PRODUCT / PROCESS CHANGE NOTIFICATION

PCN-000826

PROCESS UPDATE:

Semtech has qualified its tier 2 supplier to change the substrate's Ni/Au plating process from TSG (Traditional Selective Gold) to DPS (Double Pattern Sputter).

- **Process Flow Comparison**

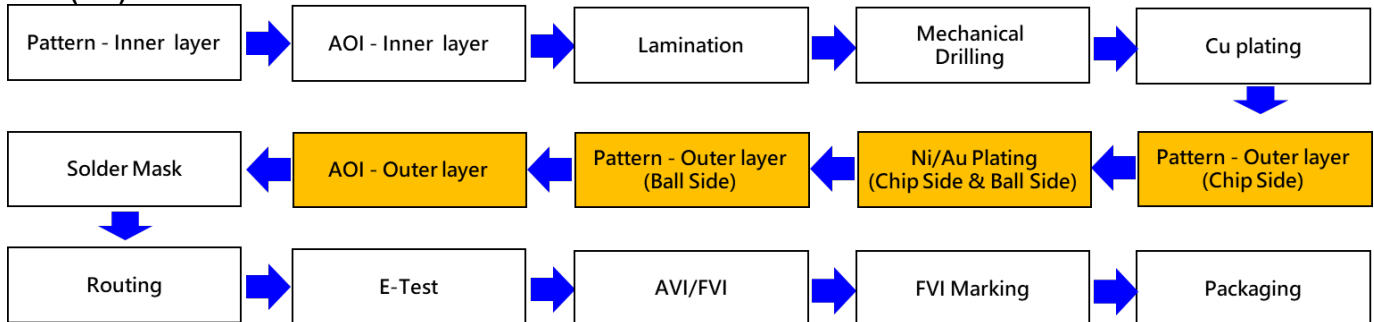
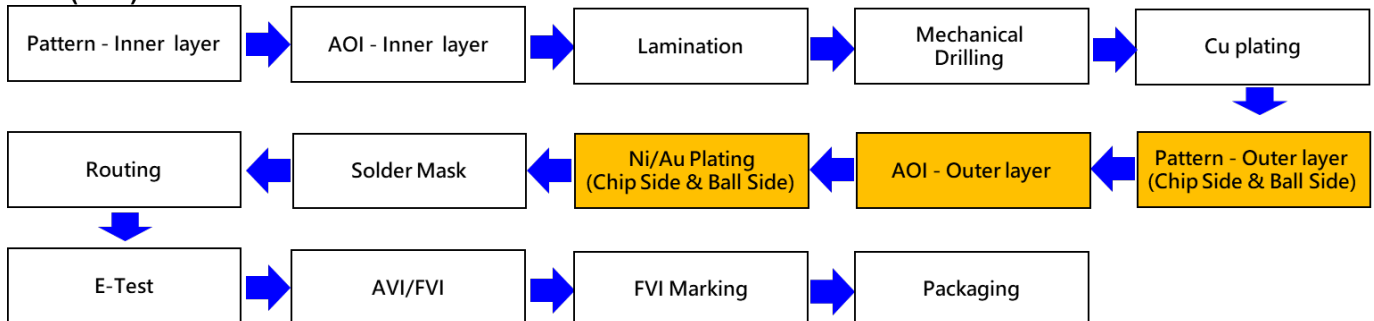
TSG (old)

DPS (new)

TSG (old)

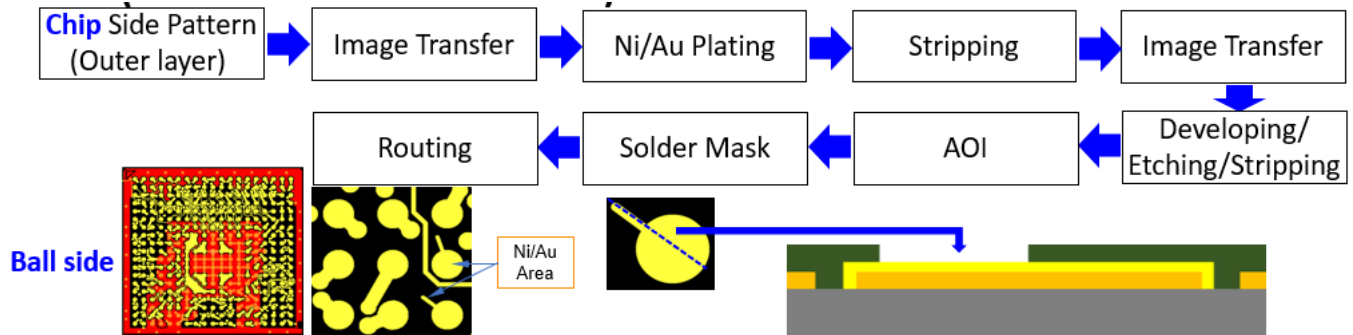
The trace & ball pad of ball side with Ni/Au plating.

DPS (new)

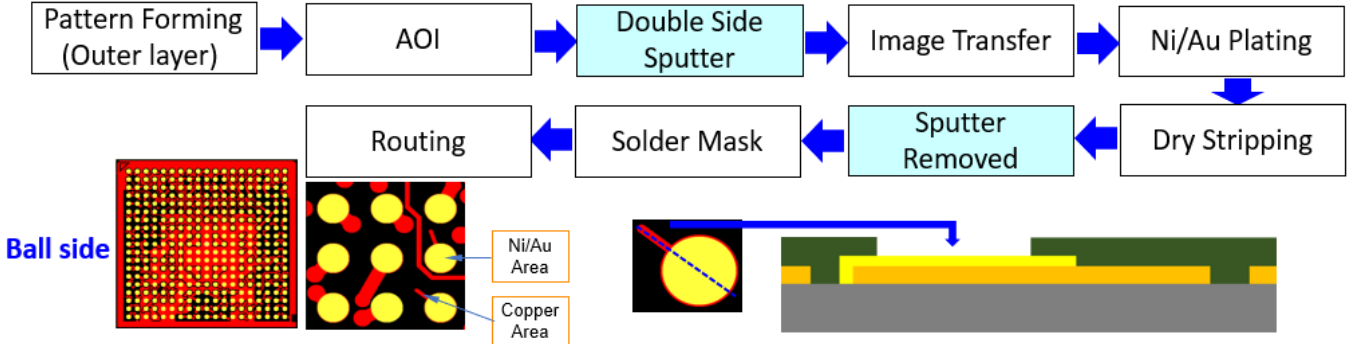
Only ball pad of ball side with Ni/Au plating.
